PoDL PD V_{on} , V_{off} , and R_{Loop} Specifications

IEEE802.3bu Task Force

May 2015

Example D1.0 Specification: Class I (12V)

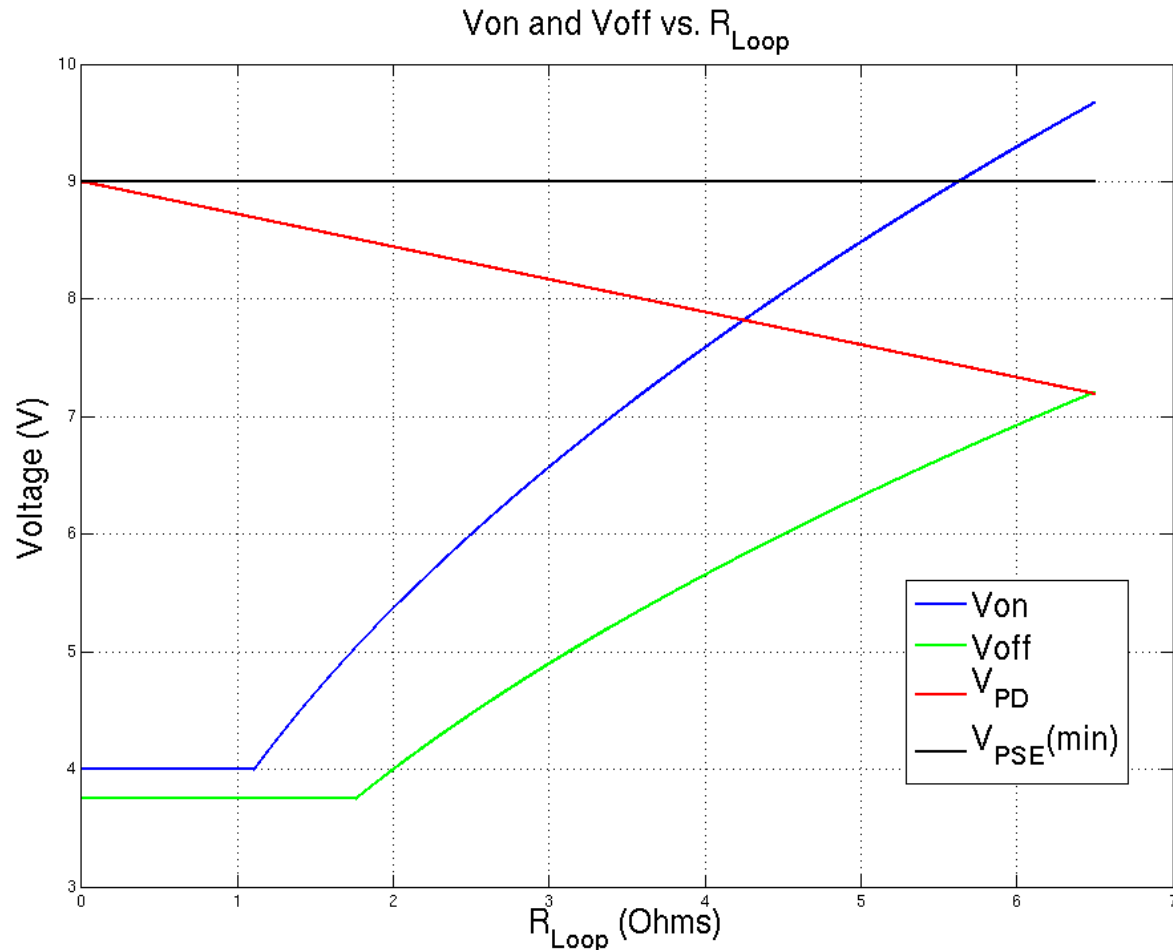
- This requires that the PD controller know both the power it will draw and the loop resistance.
 - This would be very expensive to implement, particularly for PDs in systems that do not implement SCCP.
- In addition, the $R_{Loop(max)}$ values currently listed in Table 104-1 result in turn on voltages that are higher than $V_{PSE(min)}$.

- Plot shows V_{on} and V_{off} as a function of R_{Loop} for values of R_{Loop} less than or equal to $R_{Loop(max)}$
- Note that V_{on} is higher than $V_{PSE(min)}$ for R_{Loop} values greater than $\sim 5.5\Omega$.
- Also note that the minimum V_{off} requirement is exactly the minimum requirement for system stability.
- Furthermore, the PD voltage actually intersects this curve when $R_{Loop} = R_{Loop(max)}$.
- The minimum V_{on} curve provides $\sim 34\%$ margin over the stability requirements.
- All of the classes listed in Table 104-1 have analogous graphs (see Appendix).

Example of Proposed Specification

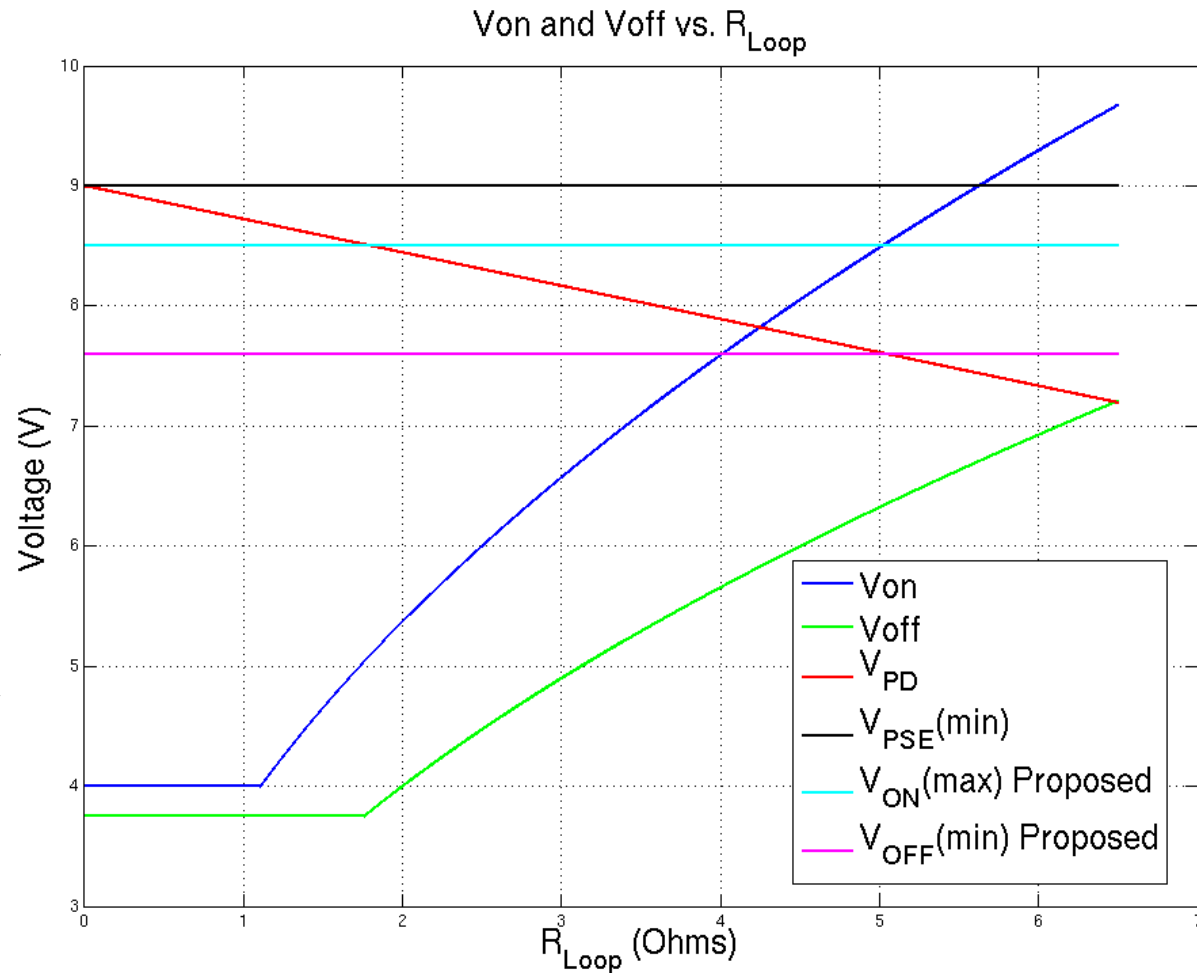
- Plot shows existing specifications and an example of the proposed specifications for the Class I (12V).
- The PD must turn on by $V_{on(max)}$ when the voltage is rising. This example is 5% lower than $V_{PSE}(min)$.
- The PD must turn off by $V_{off(min)}$ when the voltage is falling. This example is 5% higher than the stability point.

- Replace PD V_{on} and V_{off} specifications that are currently stated as equations and apply to all voltage classes with:
 - A maximum V_{on} specification for each voltage class.
 - A minimum V_{off} specification for each voltage class.
 - All specifications shall be TBD until the level of hysteresis needed is determined.
